The Corporation of the  
Town of Milton  
Committee of Adjustment and Consent

Thursday, November 28, 2024, 6:00 p.m.  
Council Chambers - In Person

File No: A-24-051M

Subject: 1316 Britton Crescent

Figure 1 - Site Plan (1316 Britton Crescent) dated October 18<sup>th</sup>, 2024.

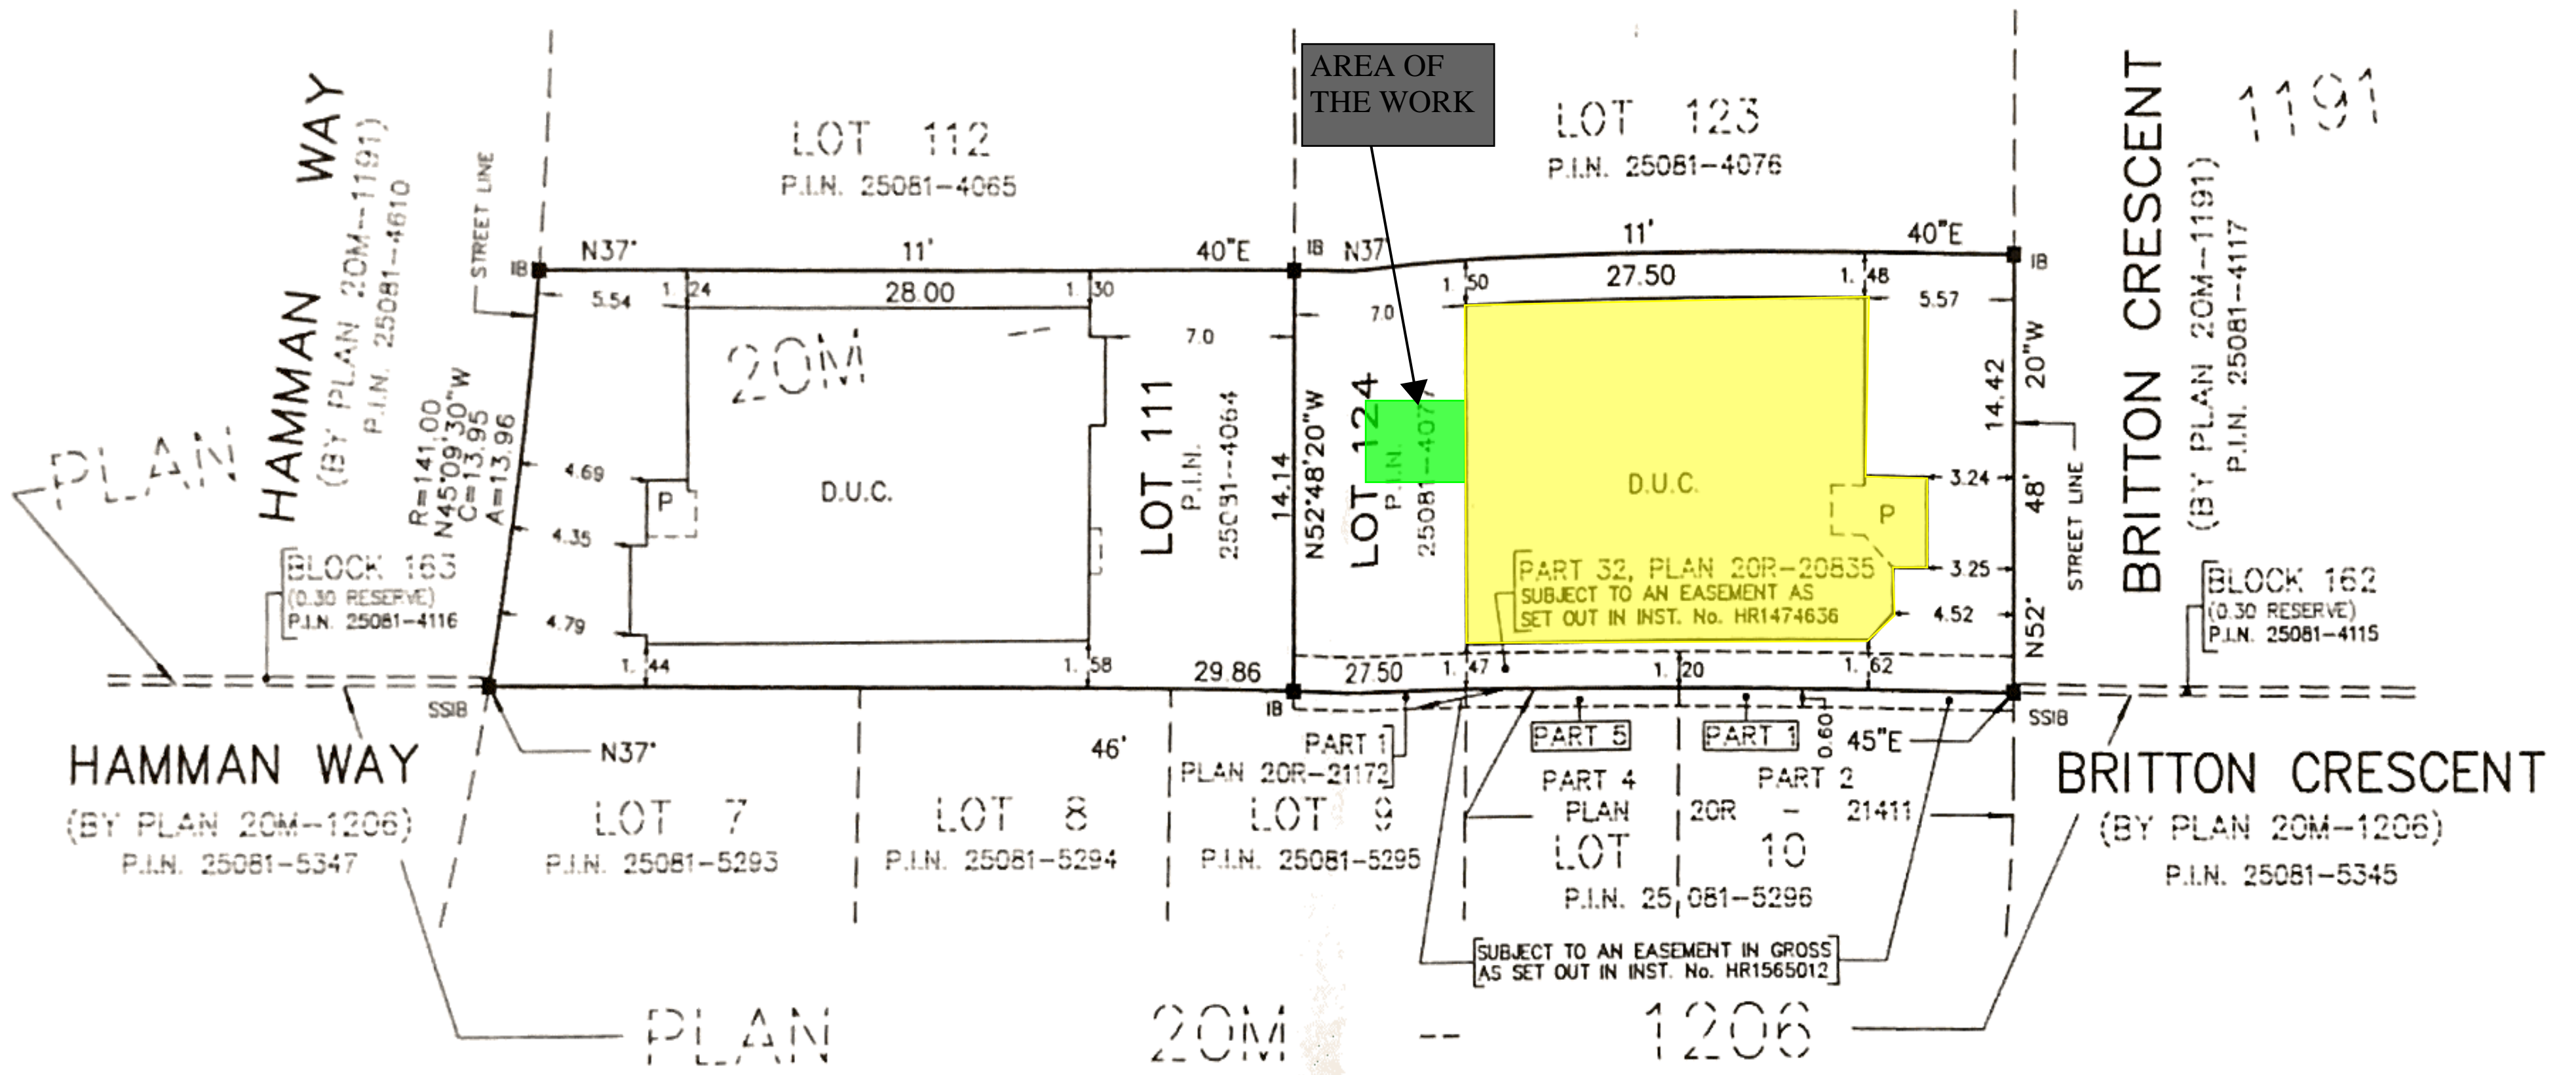
- Requesting permission to allow the rear yard setback to be 2.07 metres, whereas the Zoning By-law requires a minimum of 3 metres.

The applicant is proposing a build a rear yard porch/veranda (patio cover on top of an existing concrete slab) in the rear yard. Due to the size of the cover, a variance is require in order to allow a rear yard setback of 2.07 metres whereas the Zoning By-law requires a minimum of 3 metres.

Section 4.19.5 i), Table 4H of the Zoning By-law requires a rear yard setback of 3 metres. The proposed structure encroaches in to the rear yard setback, leaving a setback of 2.07 metres.

The application was previously heard by the Committee of Adjustments, and the requested relief to the Zoning By-law was denied. The applicant has since revised the drawing based on feedback from Planning Staff. Planning Staff have reviewed the updated drawings and have no objection to the proposed variance.

The proposed reduction of the rear yard setback is minor in nature and does not lead to over development of the lot. The application will not have impact on the functionality of the lot or impact adjacent lots. The revisions to the drawings have allowed for access throughout the lot as well as ensure there is adequate rear yard amenity space.

1. That the development shall be located and constructed in accordance with the site plan and building elevations, prepared by Donya Abasiliasi. date stamped by Town Zoning on October 18th, 2024.
2. That a building permit application be obtained within two (2) years from the date of this decision; and,
3. That the approval be subject to an expiry of two (2) years from the date of decision if the conditions are not met, if the proposed development does not proceed and/or a building permit is not secured.

Figure 1 - Site Plan (1261 Rose Way) dated October 16<sup>th</sup>, 2024.

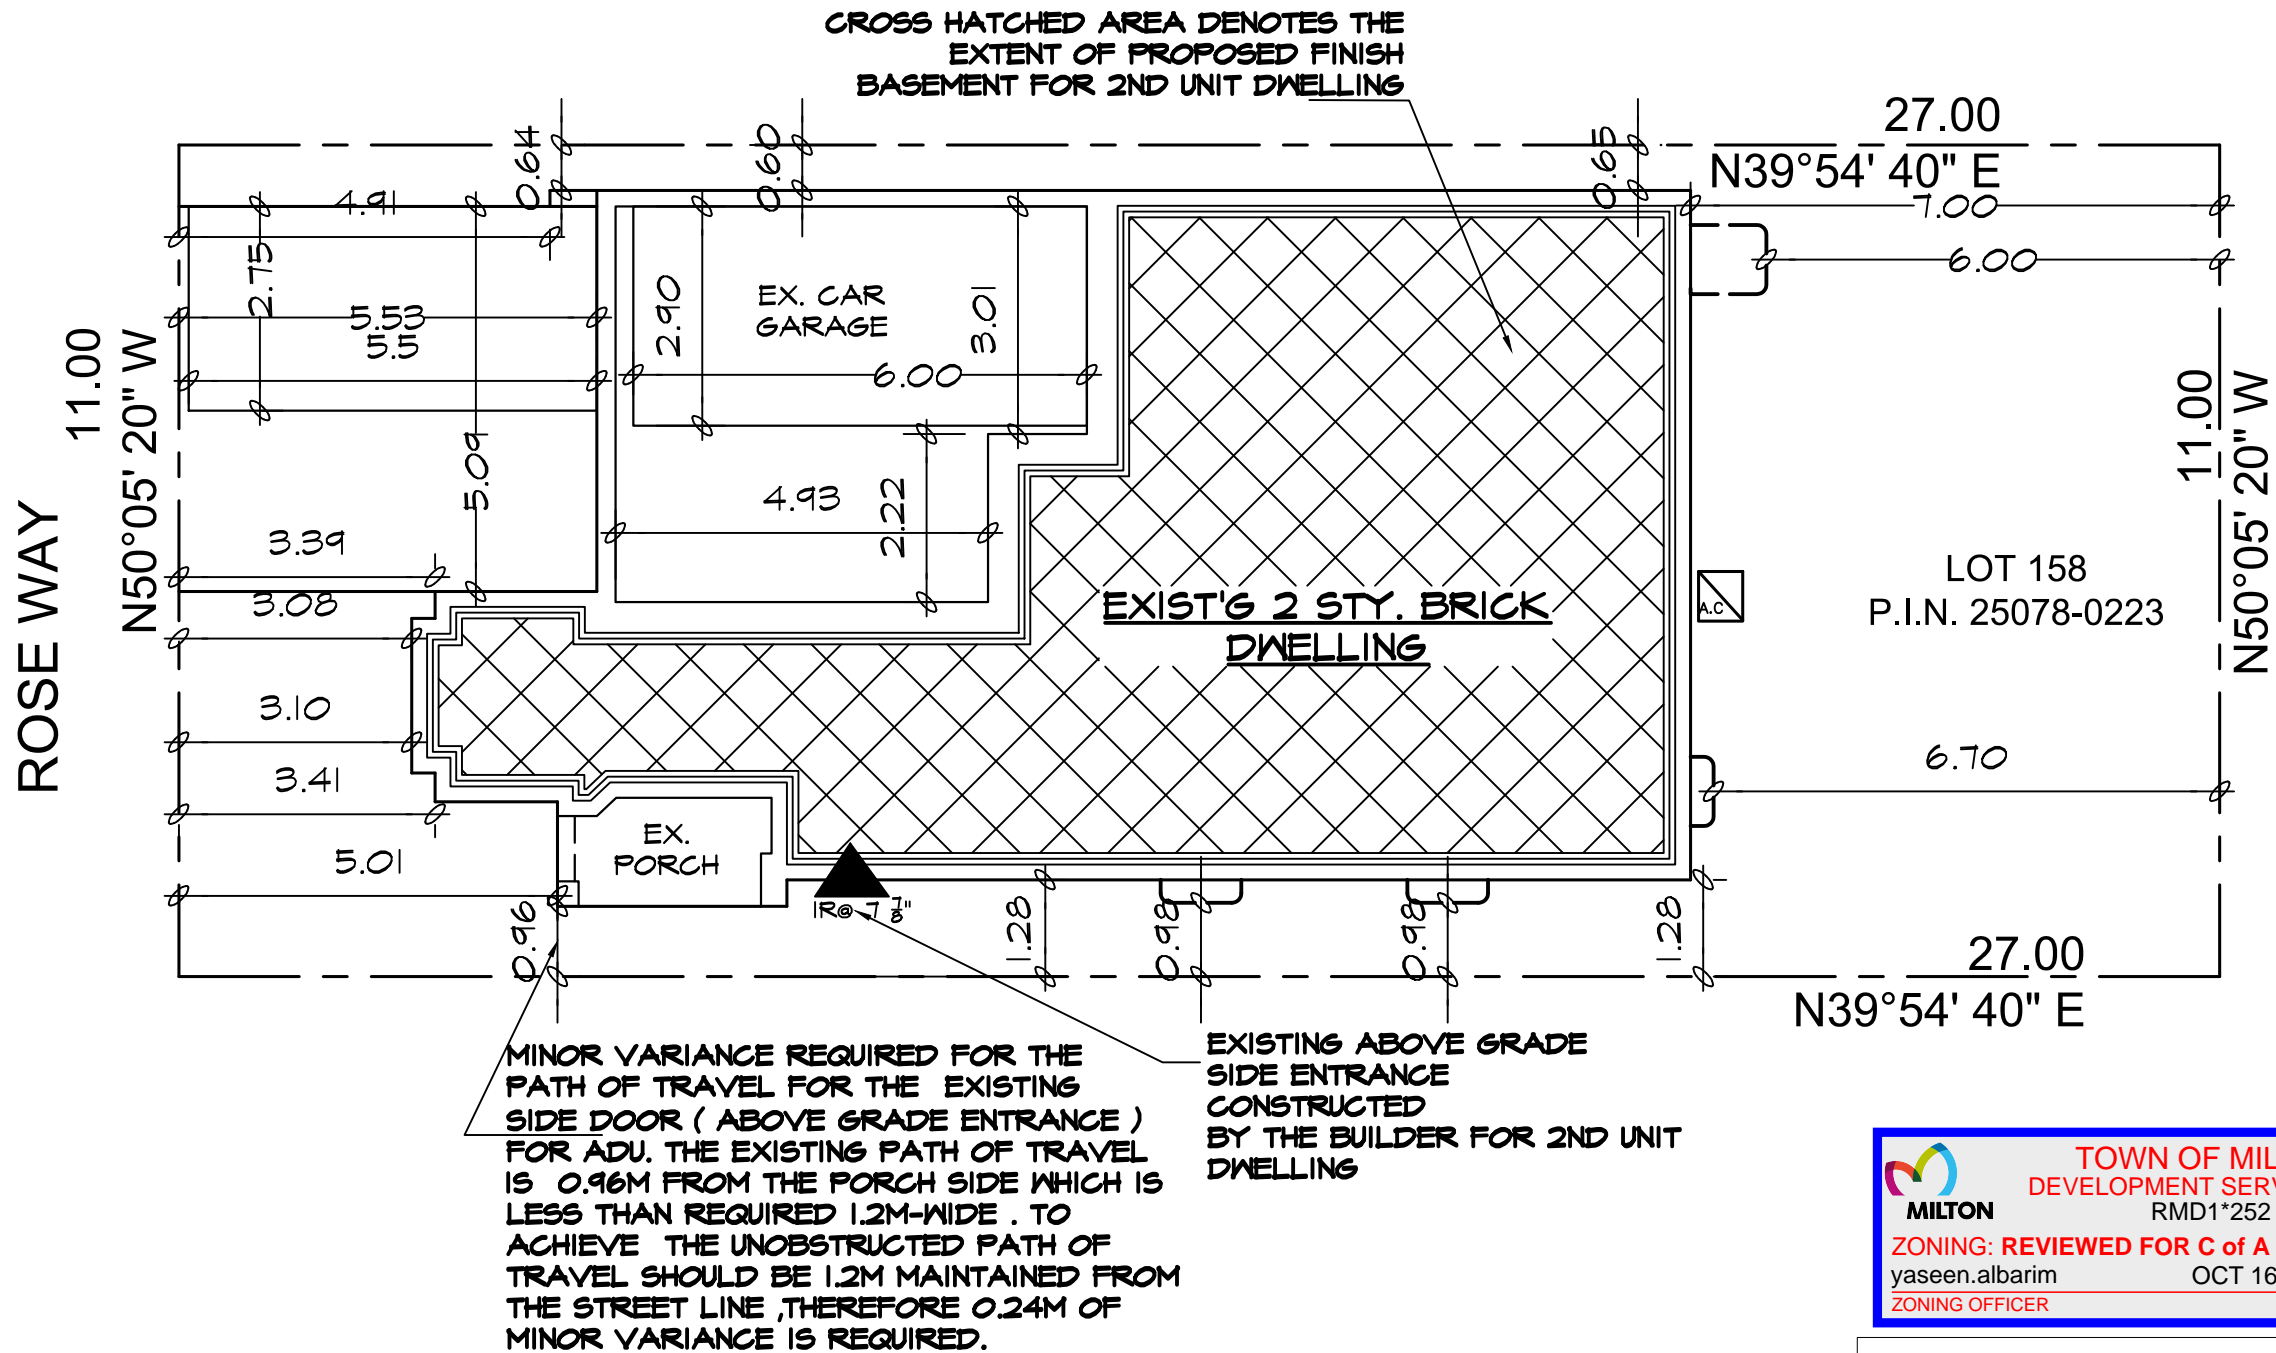
- Allow an existing porch to encroach 0.24 metres into a required 1.2 metre unobstructed pedestrian access, whereas the Zoning By-law does not permit porches to encroach in the 1.2 metre unobstructed pedestrian access.

Section 4.10 vi) of the Zoning By-law requires an unobstructed pedestrian access with a minimum width of 1.2 metre. The applicant is seeking relief to allow an existing porch to encroach within the access by 0.24 metres, resulting in a setback of 0.96 metres.

In order for a permit to be issued to construct an Additional Residential Unit, all relevant Zoning By-law provisions must be met, including the provision of the 1.2 metre unobstructed pedestrian access. The home has an existing porch currently obstructing the 1.2 metre access and results in a setback of 0.96 metres where the porch is located.

The intention of the 1.2 metre unobstructed pedestrian access is to allow for a free and clear path of travel for both the residents' use, along with fire and life safety personnel. The Zoning By-law permits certain encroachments (i.e. window wells) up to 0.30 metres within the required unobstructed pedestrian access; however, porches are not included in the list of permitted encroachments.

Planning Staff is of the opinion that permitting the porch to encroach 1.2 metres into the required unobstructed access will not hinder the intended function of the pedestrian access nor pose a hazard to users. Further, the Town of Milton Fire department was circulated on the application and did not have any concerns regarding the application, subject to the applicant installing residential sprinklers within the unit.

1. That the development shall be located and constructed in accordance with the site plan and building elevations, prepared by Farrukh Shahbaz, date stamped by Town Zoning on October 16th, 2024;
2. That a Residential Sprinkler System be included in the plans submitted for Building Permit;
3. That a building permit application be obtained within two (2) years from the date of this decision; and,
4. That the approval be subject to an expiry of two (2) years from the date of decision if the conditions are not met, if the proposed development does not proceed and/or a building permit is not secured.

Figure 1 - Site Plan (1416 Sycamore Garden) dated November 5<sup>th</sup>, 2024

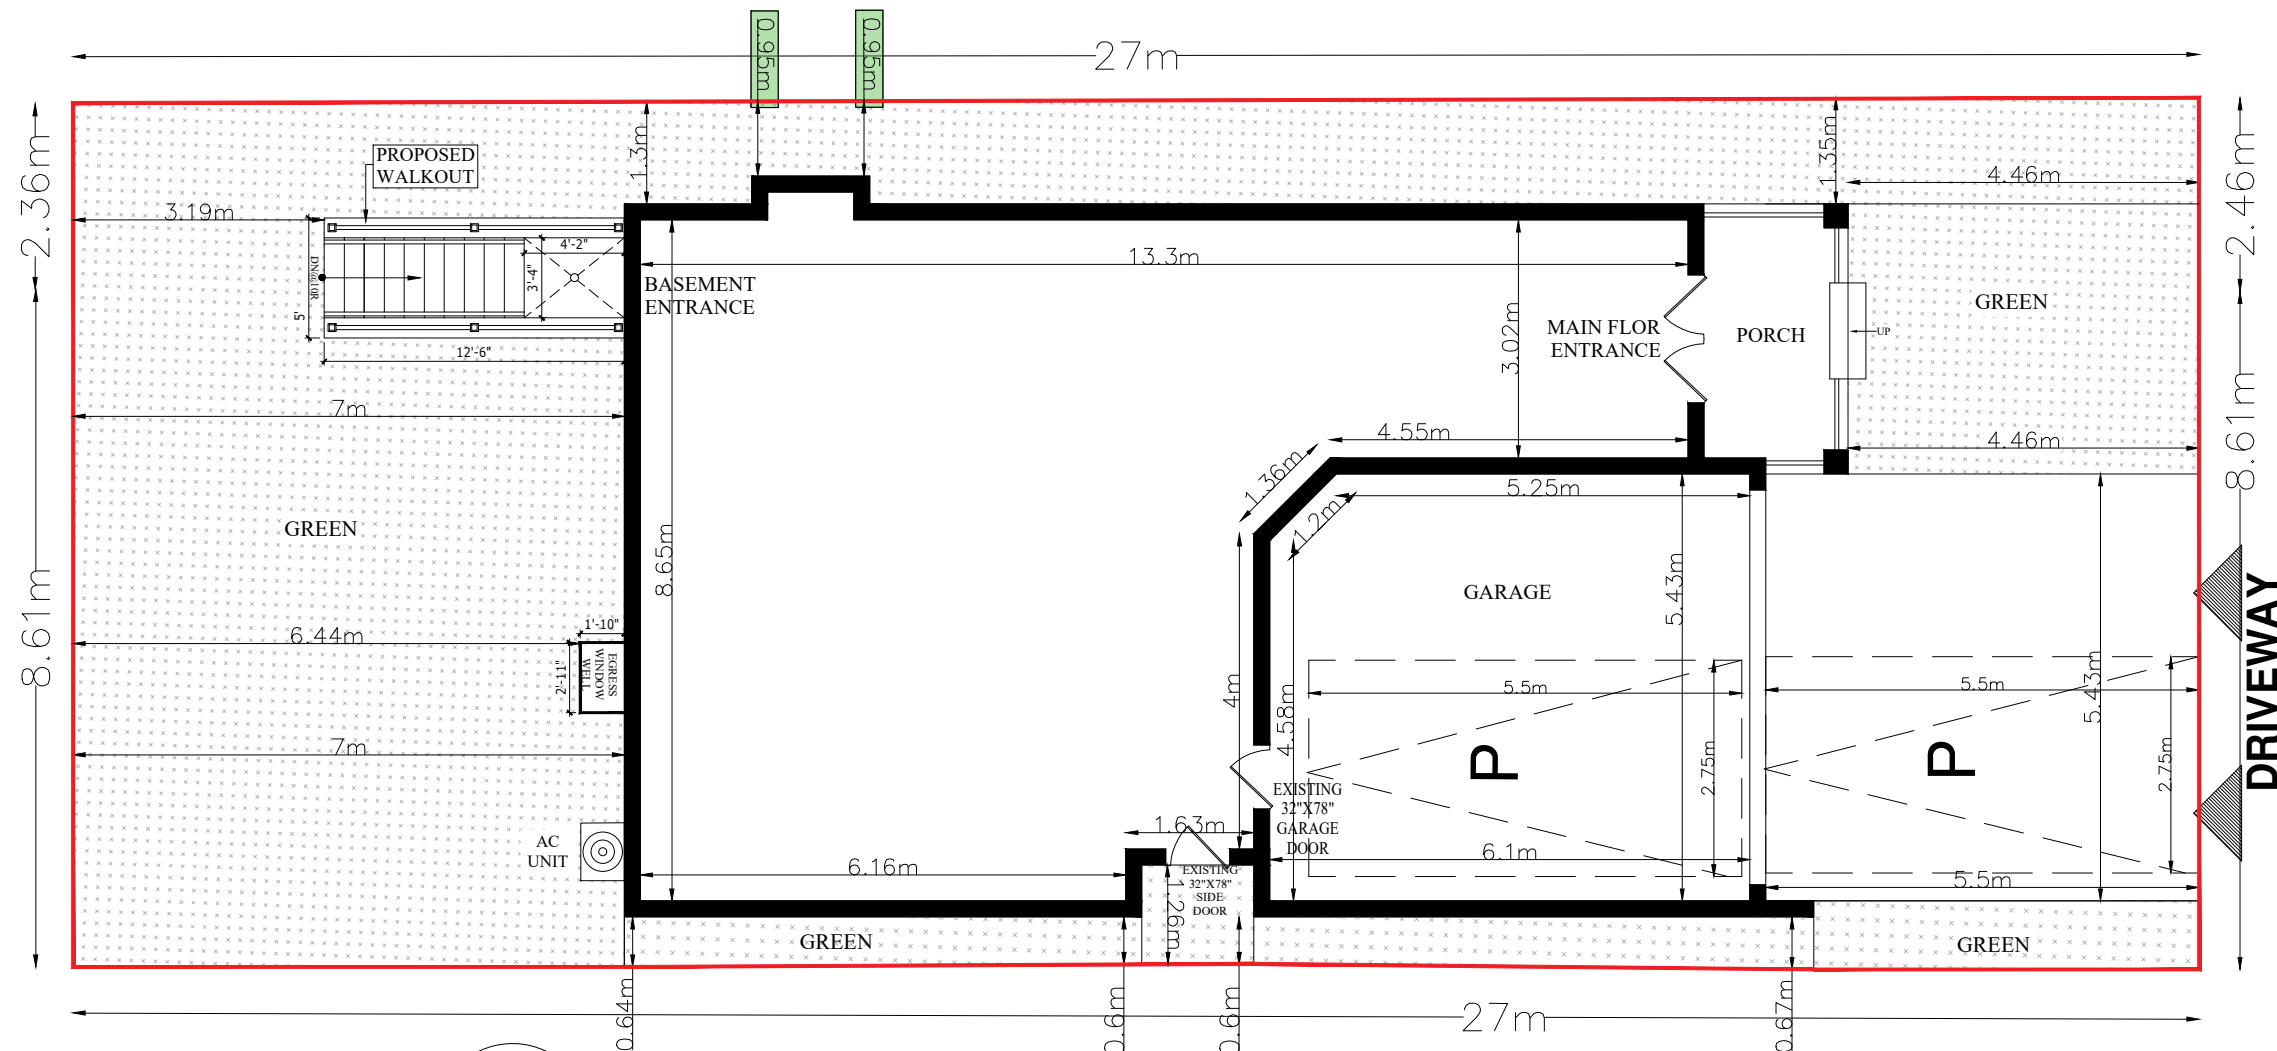
- Allow an existing chimney to encroach 0.25 metres into a required 1.2 metre unobstructed pedestrian access, whereas the Zoning By-law does not permit chimneys to encroach in the 1.2 metre unobstructed pedestrian access.

Section 4.10 vi) of the Zoning By-law requires an unobstructed pedestrian access with a minimum width of 1.2 metres. The applicant is seeking relief to allow an existing chimney to encroach within the access by 0.25 metres, resulting in a setback of 0.95 metres.

In order for a permit to be issued to construct an Additional Residential Unit, all relevant Zoning By-law provisions must be met, including the provision of the 1.2 metre unobstructed pedestrian access. The home has an existing chimney currently obstructing the 1.2 metre access and results in a setback of 0.95 metres where the chimney is located.

The intention of the 1.2 metre unobstructed pedestrian access is to allow for a free and clear path of travel for both the residents' use, along with fire and life safety personnel. The Zoning By-law permits certain encroachments (i.e. window wells) up to 0.30 metres within the required unobstructed pedestrian access; however, chimneys are not included in the list of permitted encroachments.

Planning Staff is of the opinion that permitting the chimney to encroach 1.2 metres into the required unobstructed access will not hinder the intended function of the pedestrian access nor pose a

hazard to users. Further, the Town of Milton Fire department was circulated on the application and did not have any concerns regarding the application, subject to the applicant installing residential sprinklers within the unit.

1. That the development shall be located and constructed in accordance with the site plan and building elevations, prepared by Shivang Tarika. date stamped by Town Zoning on November 5<sup>th</sup>, 2024.
2. That a Residential Sprinkler System be included in the plans submitted for Building Permit;
3. That a Building Permit be issued within two (2) years from the date of this decision; and,
4. That the approval be subject to an expiry of two (2) years from the date of decision if the conditions are not met, if the proposed development does not proceed and/or a Building Permit is not secured.
